Appln. No. Serial No. 10/529,809
Amdt. Dated 2/7/06
First Response in Appln, Reply to Office Action of 11/07/2005
Page 7 of 11

AMENDMENTS TO THE DRAWINGS

Inventor: Hiroyuki ONUKI
Filed: March 30, 2005
Serial No. 10/519,319
Title: Mirror Device for Vehicle

FIG.3

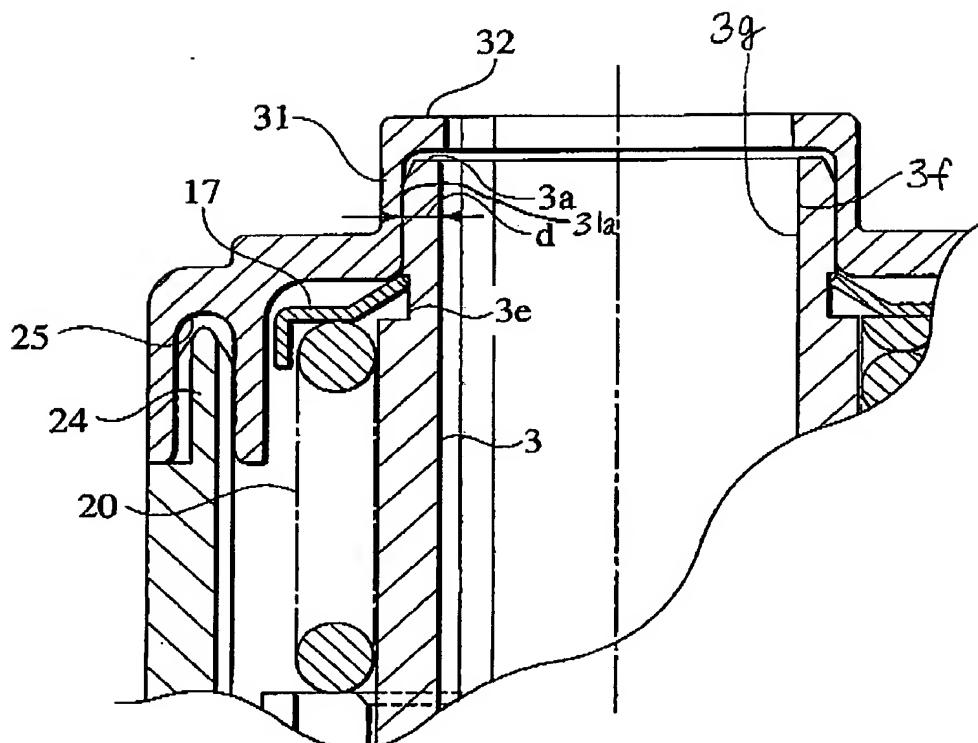
The Appendix includes annotated sheets of drawings showing changes made to Figs. 1 and 3 and replacement sheets for Figs. 1 and 3. In Fig. 1, a legend "Prior Art" has been added. In Fig. 3, reference numbers 3f, 3g, and 31a have been added.
